WALKER
APARTMENTS

B_AD PROJECT
2506
FILE: WALKER_ST_SD_CF.RVT
DATE: 08/11/2025
DRAWN BY: DK
CHECKED BY: MRB

GENERAL INFO

PROJECT DESCRIPTION:	NEW CONSTRUCTION 15 TOWNHOUSES
PROJECT ADDRESS:	19 WALKER RD, EDGEWOOD, NM 87015
ZONING:	C-2 COMMERCIAL BUSINESS ZONE
PROPERTY LEGAL DESCRIPTION:	TRACT 2, AS SHOWN ON PLATE ENTITLED LAND DIVISION PLATE OF LANDS OF MARY JANE ROSE BEING A PORTION OF N1/2 NE 1/4 SE 1/4 OF SECTION 28, T10N, R7E, N.M.P.M., FILED IN THE OFFICE OF THE COUNTY CLERK, SANTA FE COUNTY, NEW MEXICO, ON OCTOBER 28, 1980, IN PLAT BOOK 86, PAGE 032, AS DOCUMENT NO. 467,301.

EXTERIOR ELEVATIONS

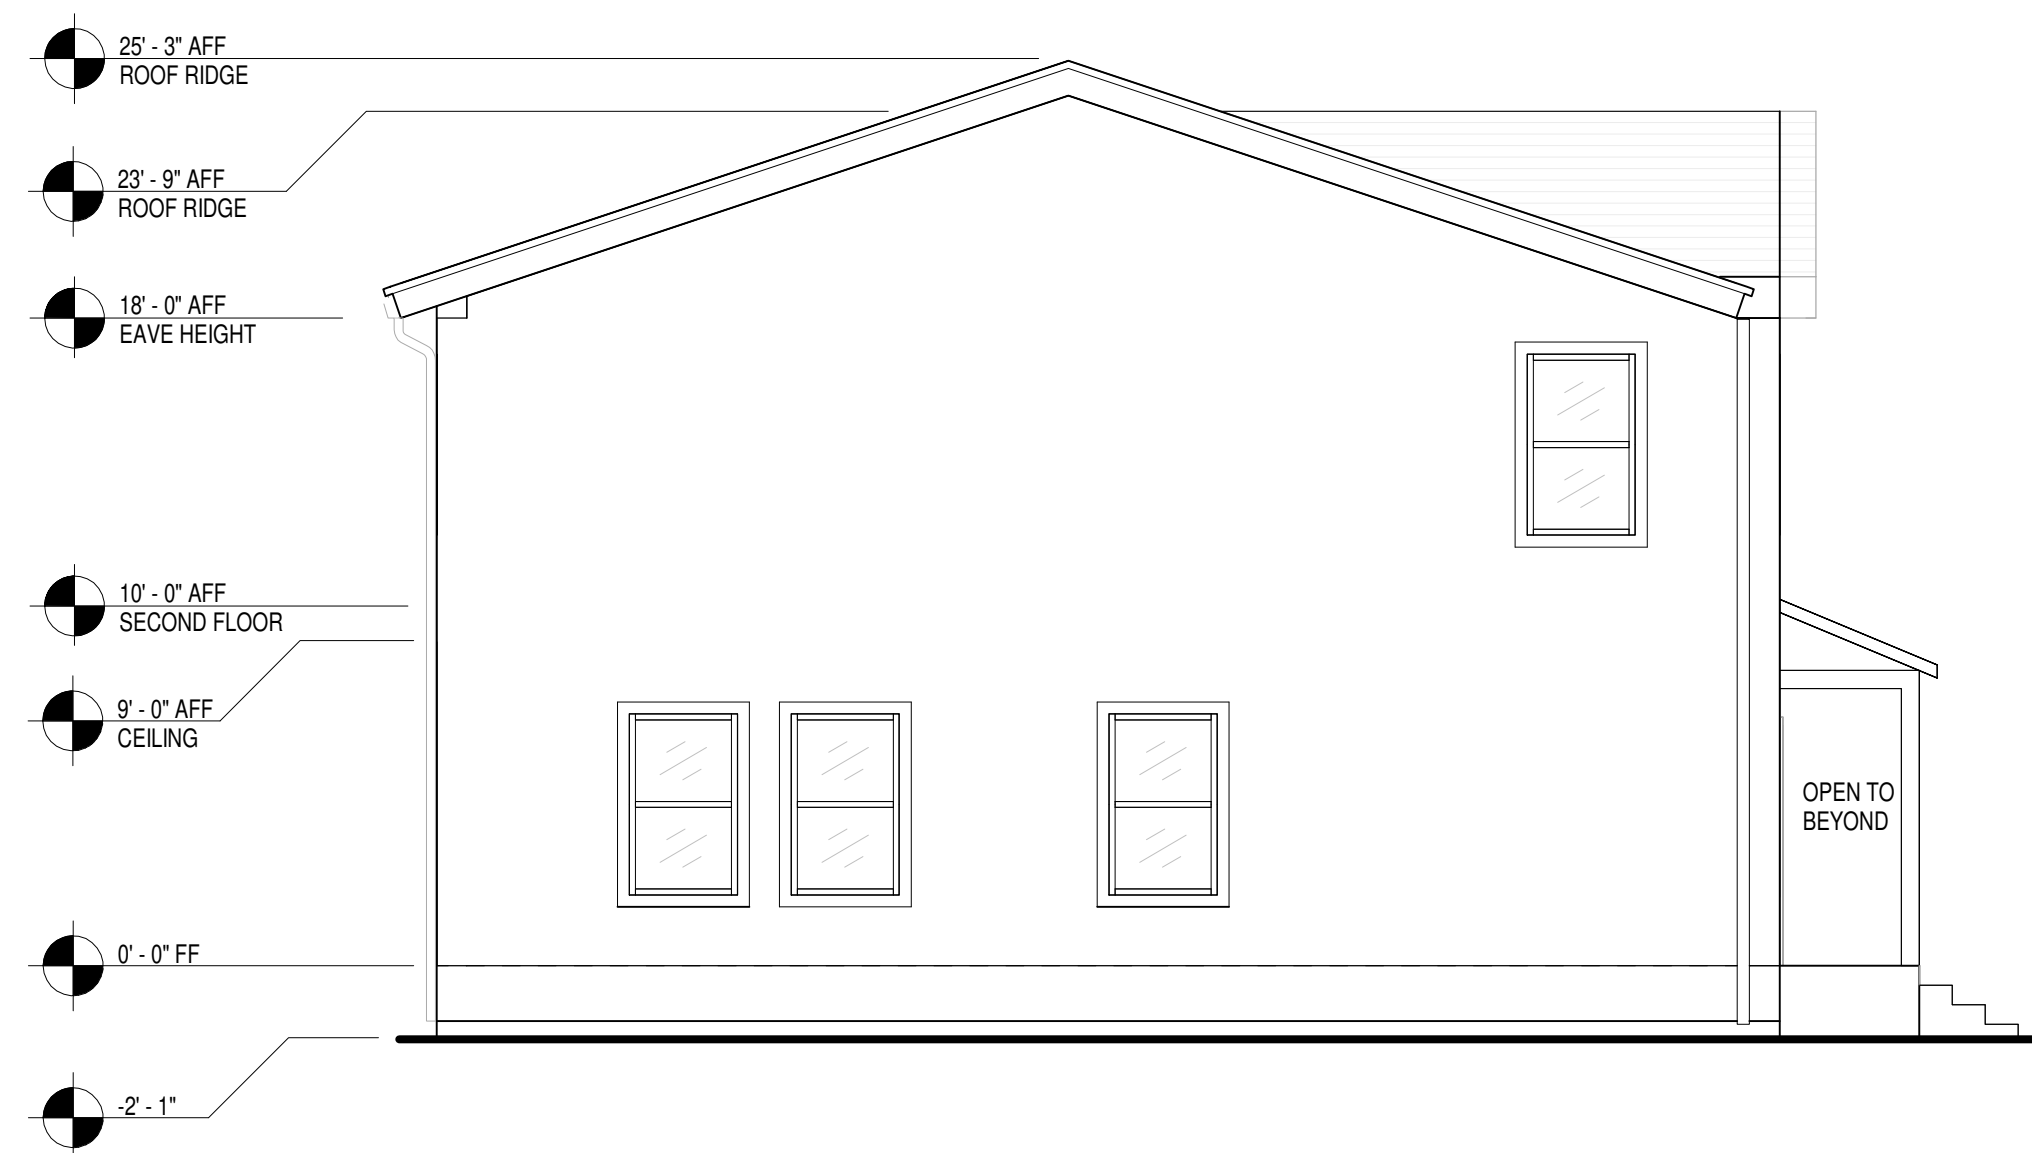
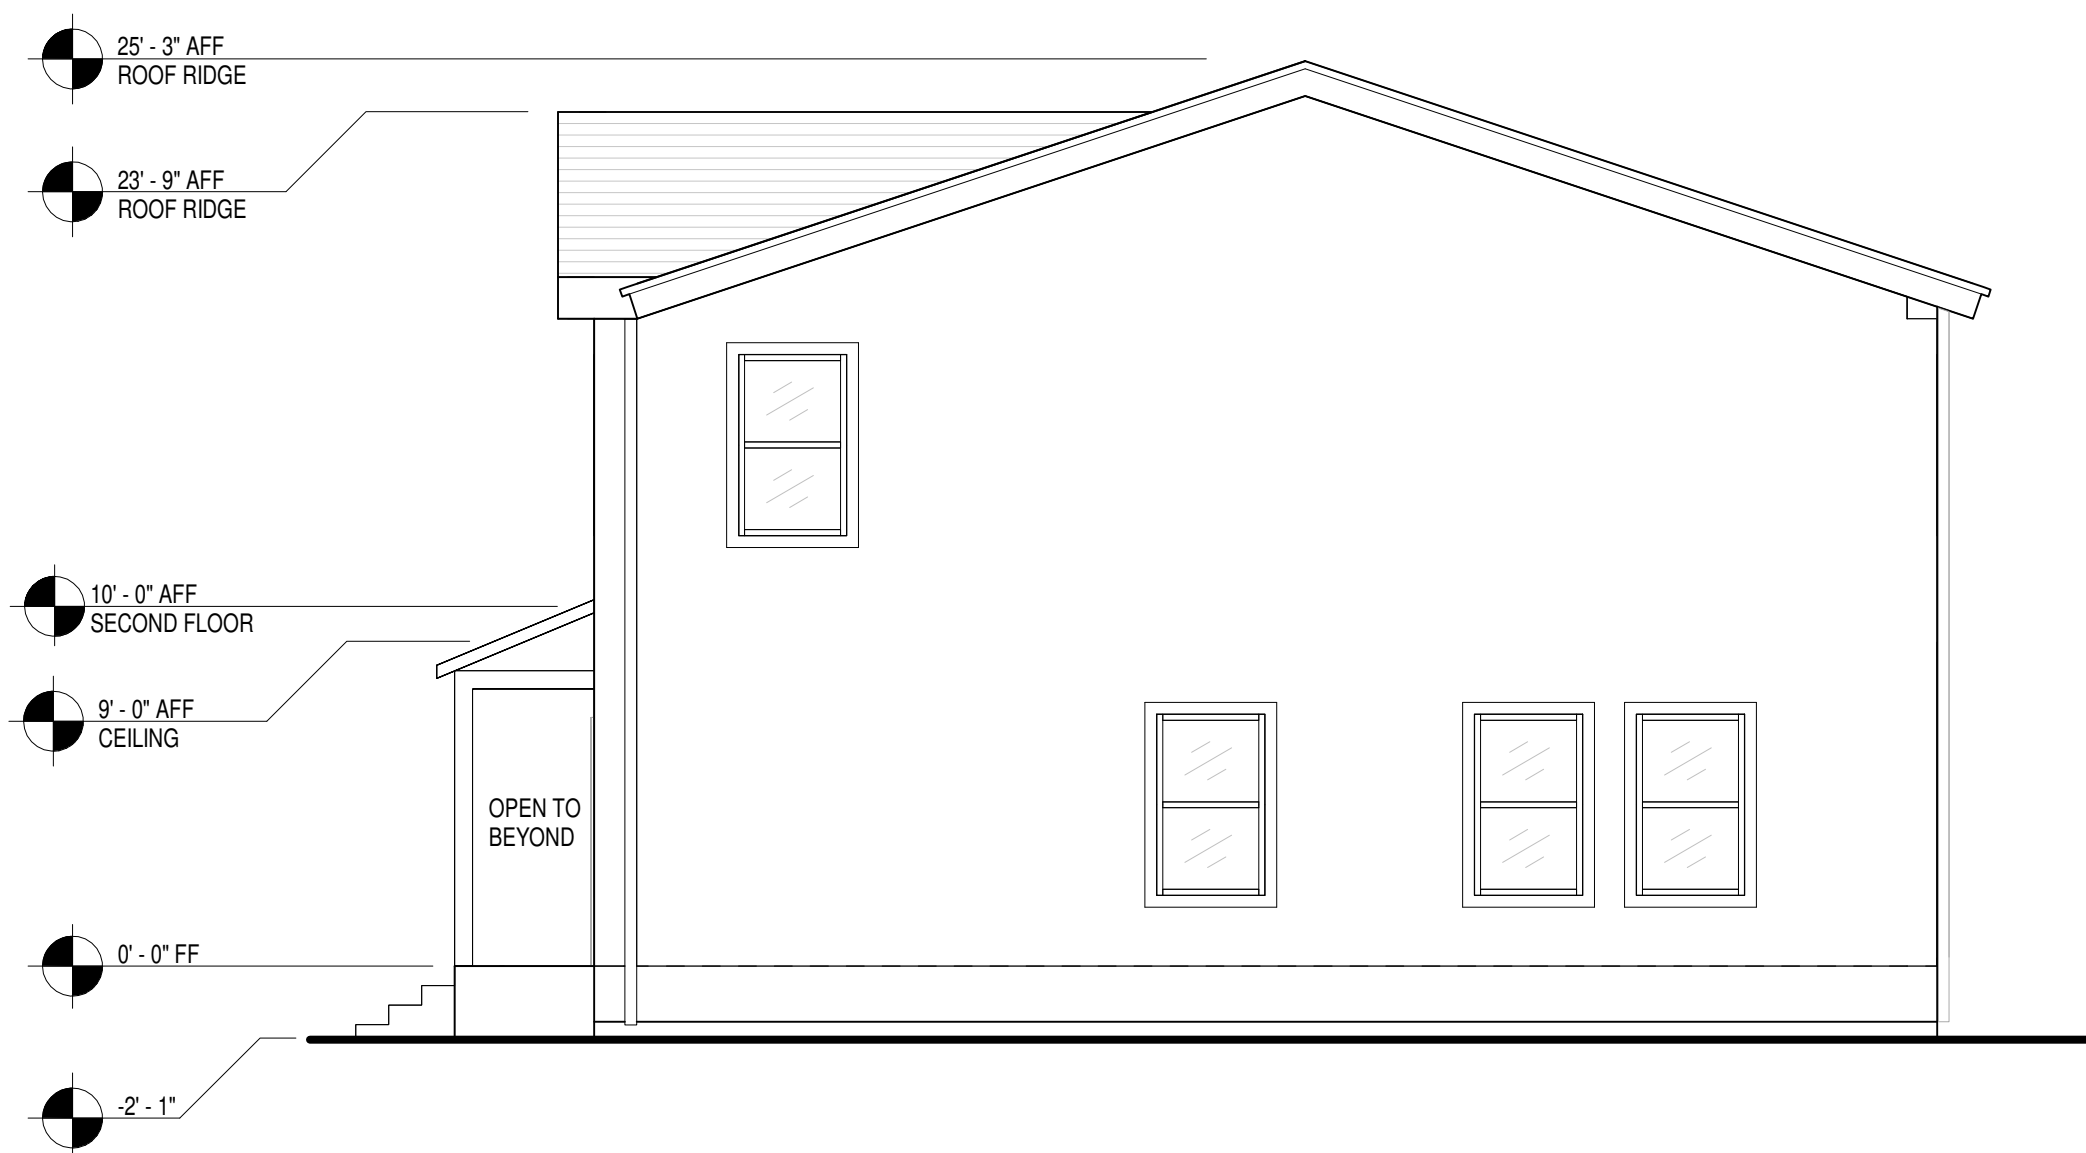
IRC
R703.7
SECTIONS
OF THE INTERNATIONAL RESIDENTIAL
CODE MUST BE COMPLIED WITH
(N.M. RESIDENTIAL BUILDING CODE)

Stucco

IRC
R905.2
SECTIONS _____
OF THE INTERNATIONAL RESIDENTIAL
CODE MUST BE COMPLIED WITH
(N.M. RESIDENTIAL BUILDING CODE)

Asphalt Shingles

C2 BUILDING D - SECTION 1
SCALE: 1/4" = 1'-0"

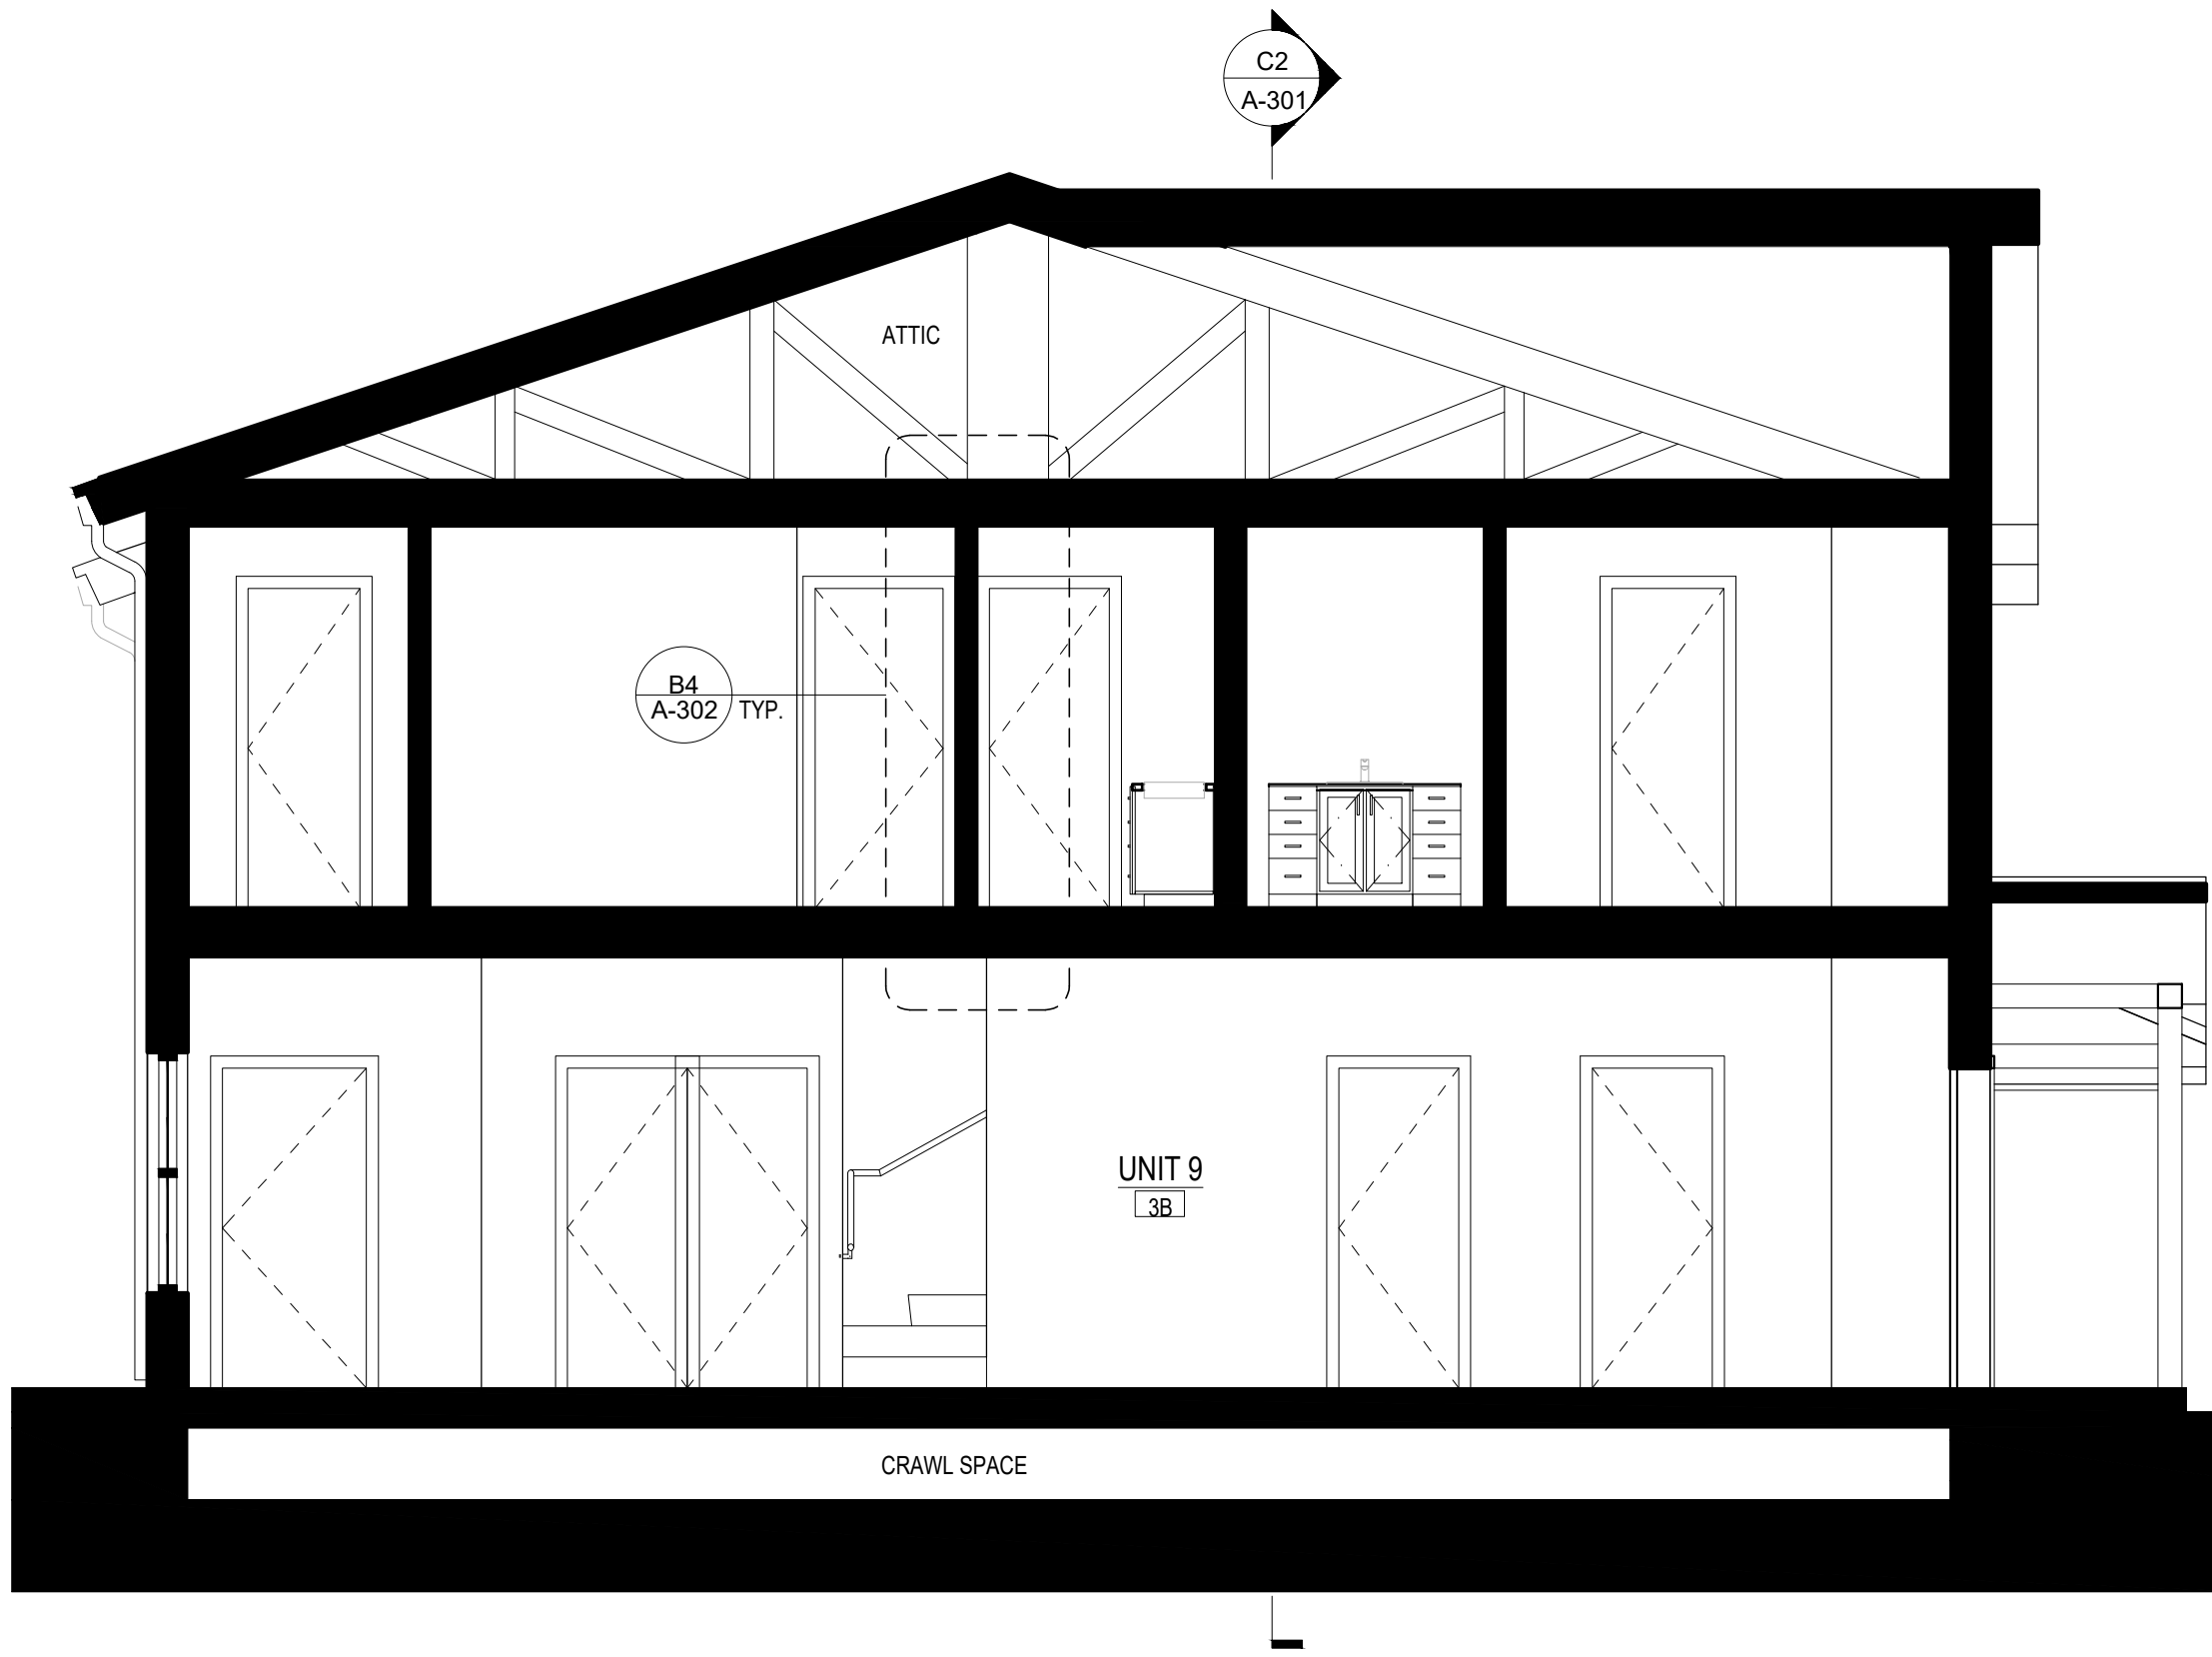
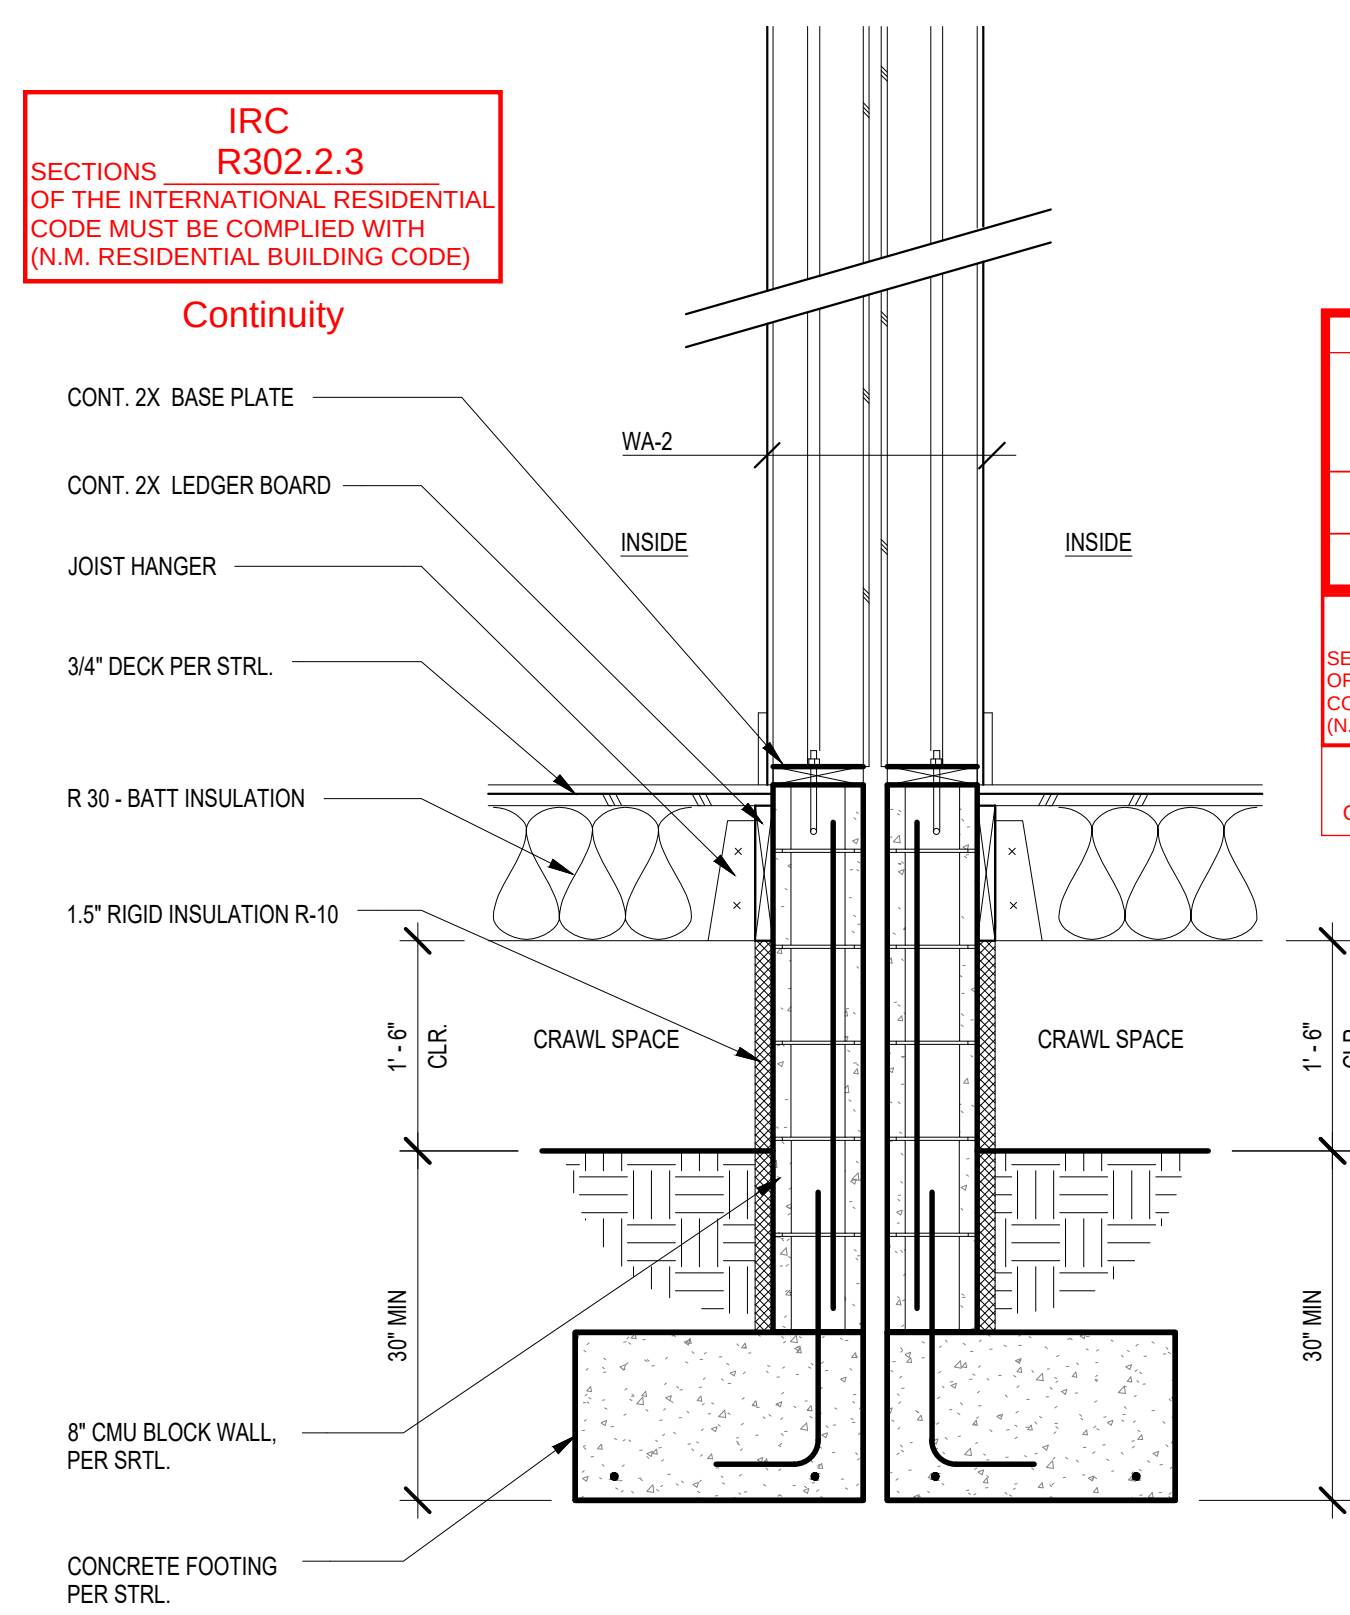
Residential Foundation
NMAC - 14.7.3.12 A Foundation
NMAC - 14.7.3.12 B (2) Foot protection
NMAC - 14.7.3.12 B (3) min. depth
NMAC - 14.7.3.11 D Garage if applies
Floor surface and slope 1/4"
311.3 exterior landings at doors

NOTE:
CONCRETE FINISHED
ELECTRODO
Construction Industries Division
2021 International Residential Building Code

IRC
SECTIONS 401/403/506
OF THE INTERNATIONAL RESIDENTIAL
CODE MUST BE COMPLIED WITH
(N.M. RESIDENTIAL BUILDING CODE)

FOUNDATIONS / FOOTINGS
REINFORCEMENT / SUPPORT
CONCRETE FLOOR ON GROUND

B5 INTERIOR PARTITION TYPES
SCALE: 1" = 1'-0"

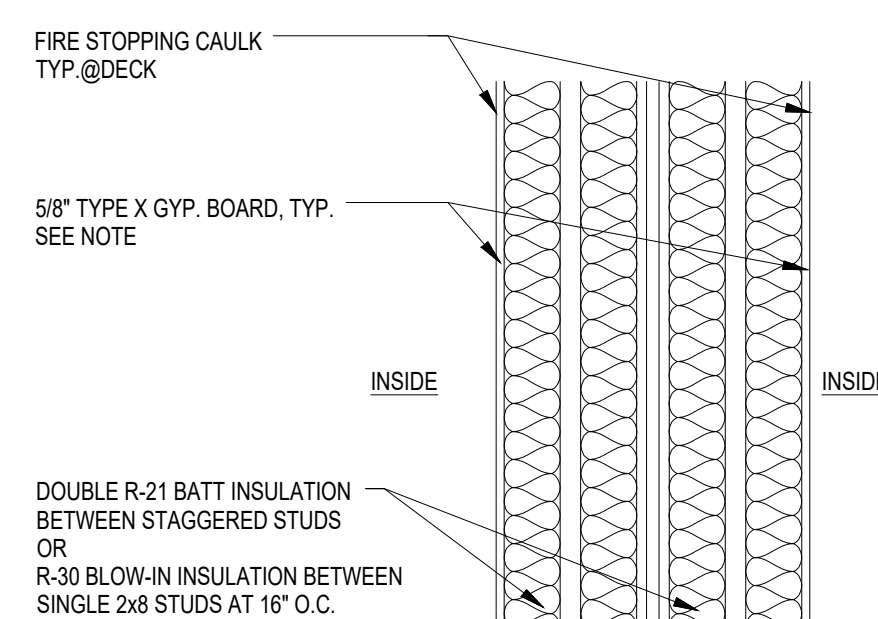
IRC
SECTIONS R302.2.2
OF THE INTERNATIONAL RESIDENTIAL
CODE MUST BE COMPLIED WITH
(N.M. RESIDENTIAL BUILDING CODE)

Common Walls
